RE: Stanberry SRTS TAP-9900(128)
Stanberry, Missouri
Addendum No. 1

Addendum No. 1**Stanberry SRTS TAP-9900(128)
Stanberry, Missouri**

A. CONTRACTOR QUESTIONS AND ANSWERS

Roberson Funeral Home

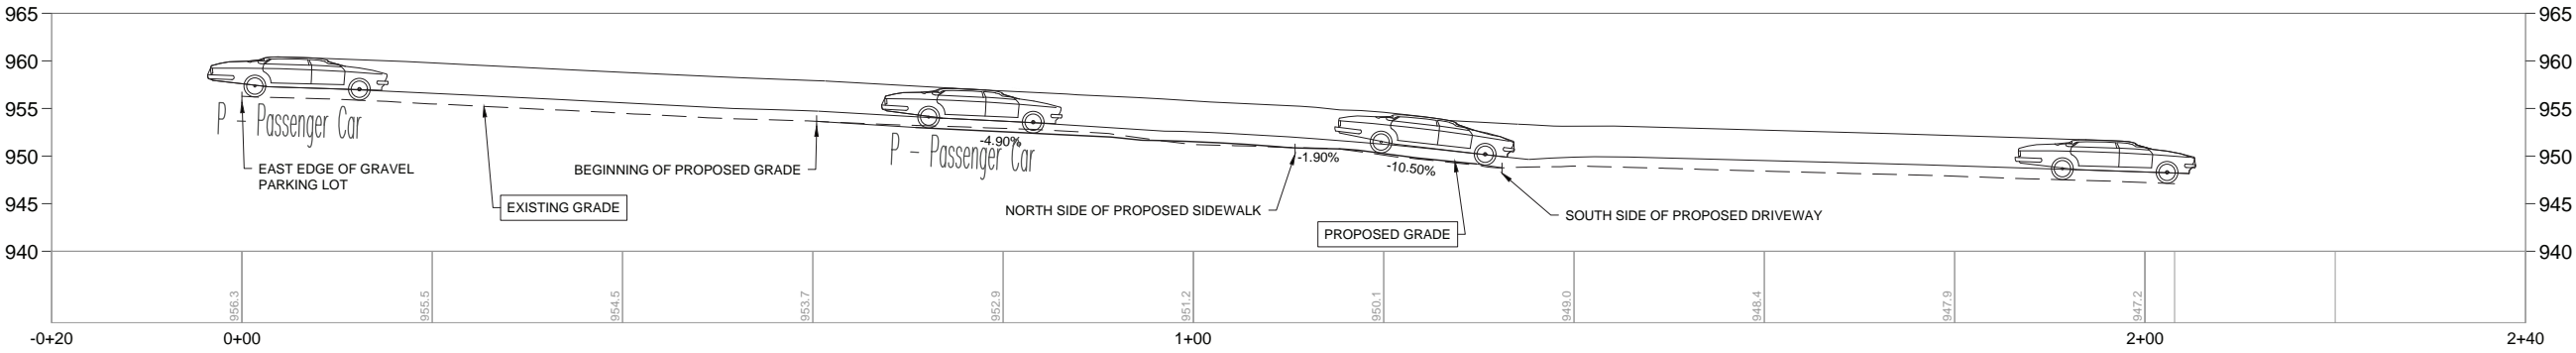
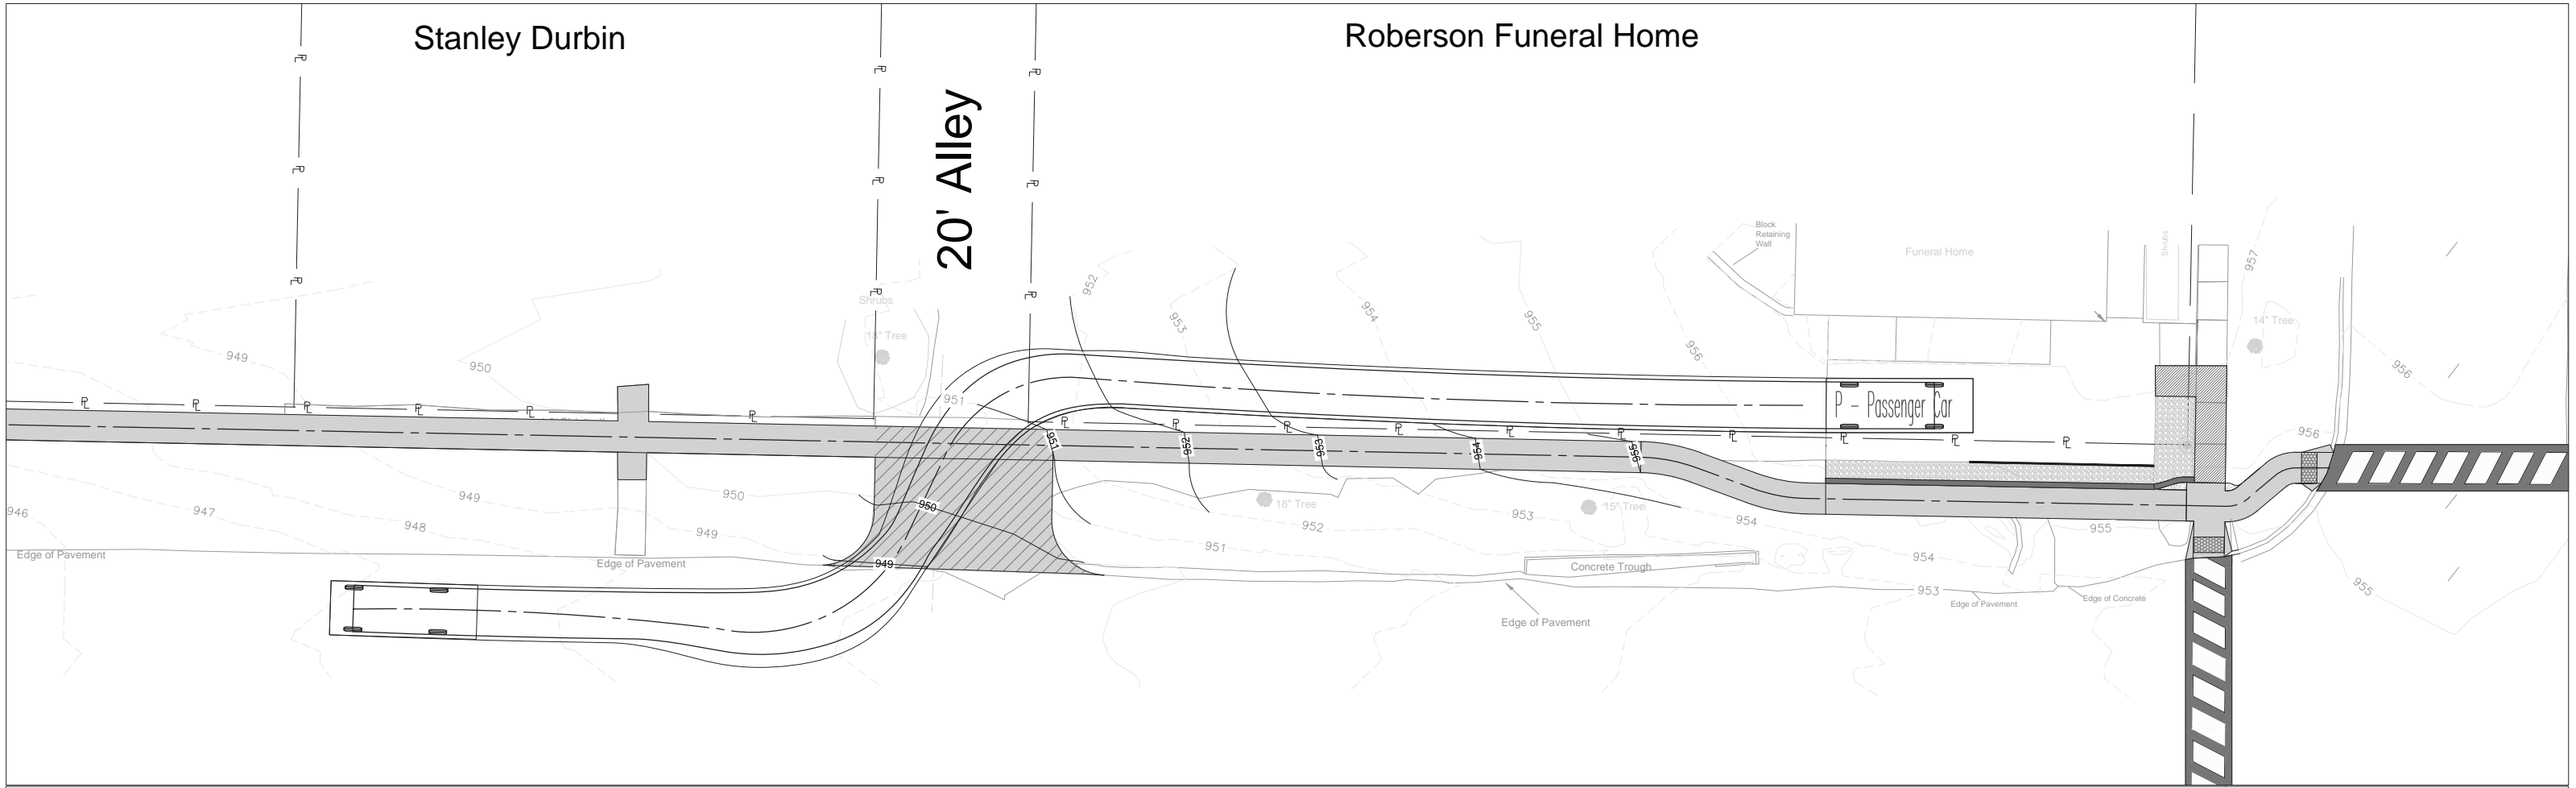
1. See attached 'Funeral Home Drive Profile' for clarification on plan grading shown on Plan Sheets 3.05 and 3.06. Plan sheets 3.05 and 3.06 remain unchanged.
